## TERRA PRO: SECOND AMENDMENT JSP 21-12

### **JSP 21-12 TERRA PRO SECOND AMENDMENT**

2<sup>nd</sup> Amendment to the PRO Plan & Agreement (JSP17-52) and 2<sup>nd</sup> Revised Final Site Plan (JSP21-12)

The current submittal is a request by the applicant to modify the PRO Agreement in three areas: 1) Eliminate the sidewalk connection from the eastern (Phase 2) portion of the site to the ITC Trail, 2) Remove a segment of sidewalk from the south side of Villa Court where it crosses the Garfield Drain, and 3) Pay into the tree fund instead of planting 51 tree credits to the north of Units 27-36.

Figure 1: PRO Agreement, Exhibit B, Sheet 4, Liber 52674 Page 562

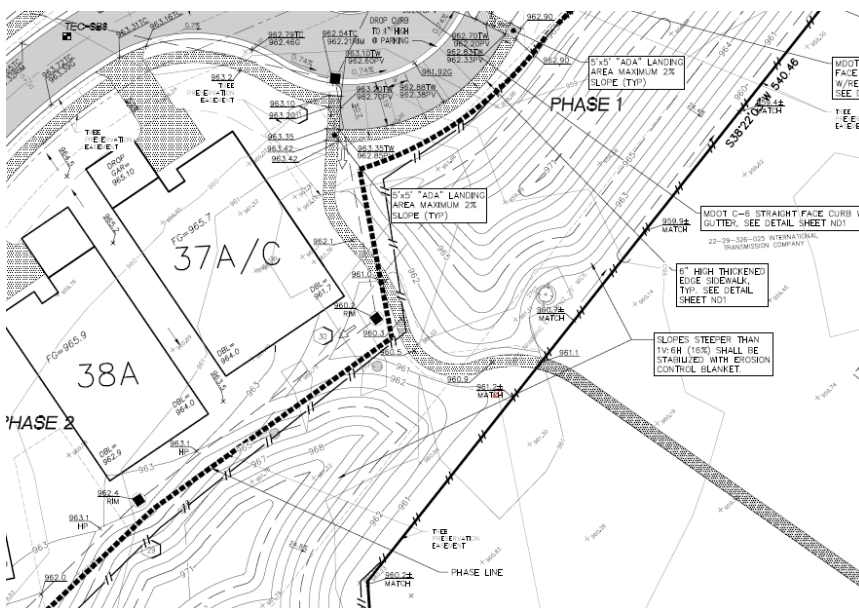
1. Sidewalk Connection to ITC Corridor: The PRO Agreement states on Page 4, Item 6: "The applicant will work with staff to identify a proper location to connect to ITC trail, beyond the subject property line." The 5-foot wide asphalt sidewalk is shown on the PRO Plan in Exhibit B of the Agreement, and in the Phase 2 site plan. The applicant states the residents of the development would like to eliminate the sidewalk connection in order to continue the berm to provide additional screening of the ITC transmission towers, as well as to limit pedestrian traffic into the community. They have provided letters from several current and future residents that echo support for eliminating the connection. They also point out that the sidewalk at the main entrance provides a connection to the ITC Trail.

While the connection to the ITC Trail is not a requirement of the Zoning Ordinance, its inclusion in the original PRO Plan and Agreement appeared to be presented as an amenity to the community. However, it was not specifically mentioned as a “public benefit” per say or stated as a requirement. Staff prefers the segment be provided in the interest of enhancing non-motorized connectivity throughout the community.

Figure 4: Original sidewalk plan, June 2021

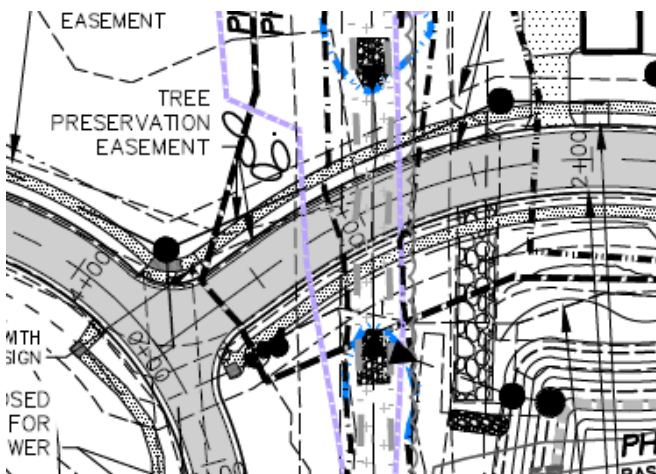
2. Sidewalk on Villa Court: The Subdivision Ordinance (Section 4.05) and the Design & Construction Standards (Section 11-256(b)) both state that sidewalks shall be provided on both sides of proposed drives. The applicant received a deviation in the original PRO Agreement to not provide a sidewalk on the east side of the main entrance drive (Villa Drive) due to the presence of wetlands, with a payment to the sidewalk fund required in lieu of building it. The applicant now requests a deviation to remove a portion of the sidewalk on the south side of Villa Court. During construction of the culvert for the Garfield Drain, the decision was made by on-site engineers to shift it to the north a few feet to avoid eroding soils over time. This change created a narrower space between the road and the slope to the culvert to place the sidewalk as shown on the original plan. Staff was made aware of the change and encouraged the applicant to work with their engineers to try to fit the sidewalk by moving it closer to the road or by building a retaining wall. The current plan shows the sidewalk ending on the south side of Villa Court about 110 feet east of the intersection with Villa Drive, with ramps provided to enable pedestrians to cross the street to connect to the north side sidewalk. No crosswalk markings are proposed. **Staff recommends the applicant adhere to the Code to provide the required sidewalk. Based on the plan it still appears feasible to fit it between the road and the culvert.**

- a. Engineering Review: **Engineering does not recommend approval of the deviation required for the missing sidewalk segment on Villa Court.**
- b. Landscape Review: **Landscaping does not recommend approval to allow the applicant to pay into the tree fund as it appears there are other locations on-site to plant them on site.**

Figure 5: Phase 2 Landscape Plan, June 1, 2021

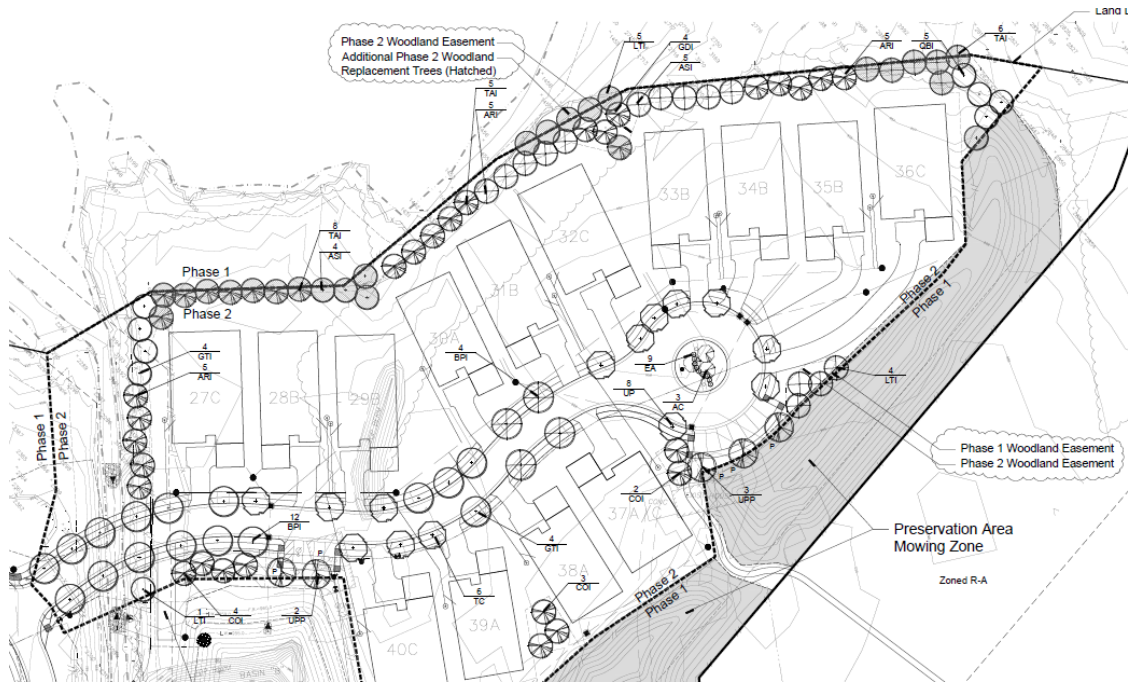
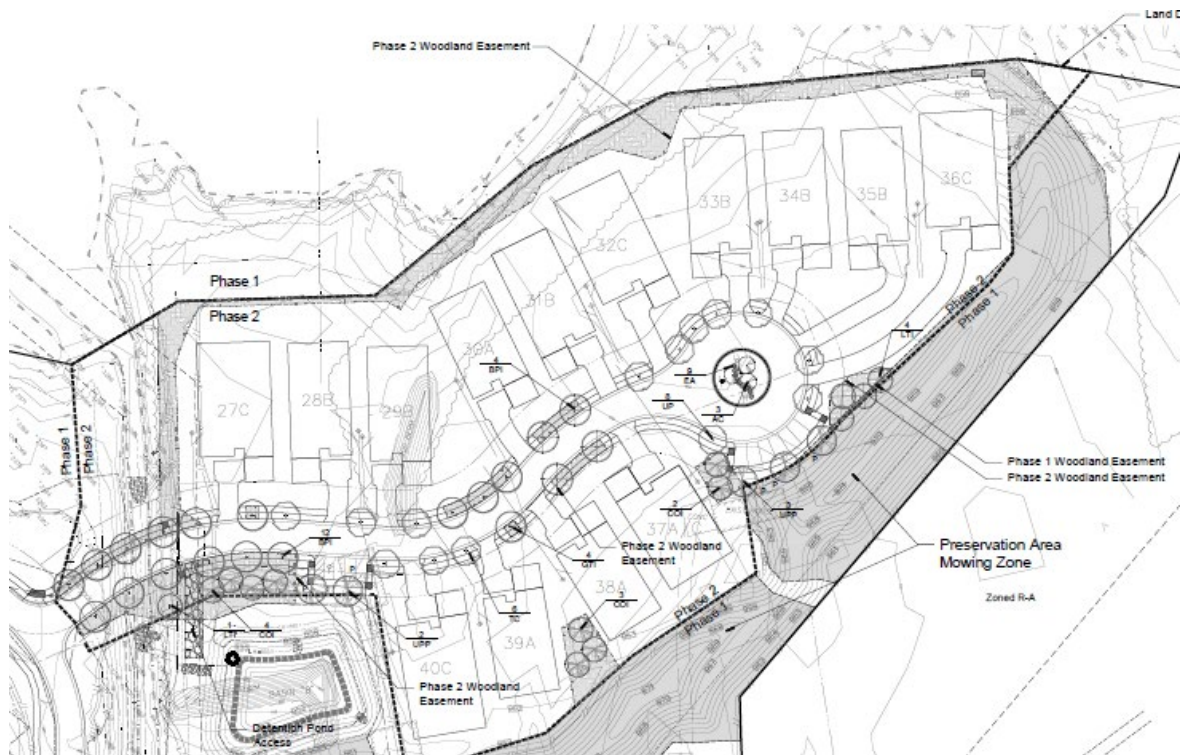
3. **Woodland Trees:** When the Phase 2 site plan was approved the applicant had shown 51 woodland replacement trees to be planted beside and behind units 27-36. The applicant would instead like to pay into the Tree Fund rather than planting the replacements on the site. The applicant states the proposed trees were going to be too close to the homes. **While the Woodland Ordinance permits applicants the option to pay into the Tree Fund, the Woodland Permit from the Planning Commission was approved with the understanding that the credits would be planted on-site. It also appears there would be additional locations on the property where woodland trees could be planted, as noted in the Landscape Review.**
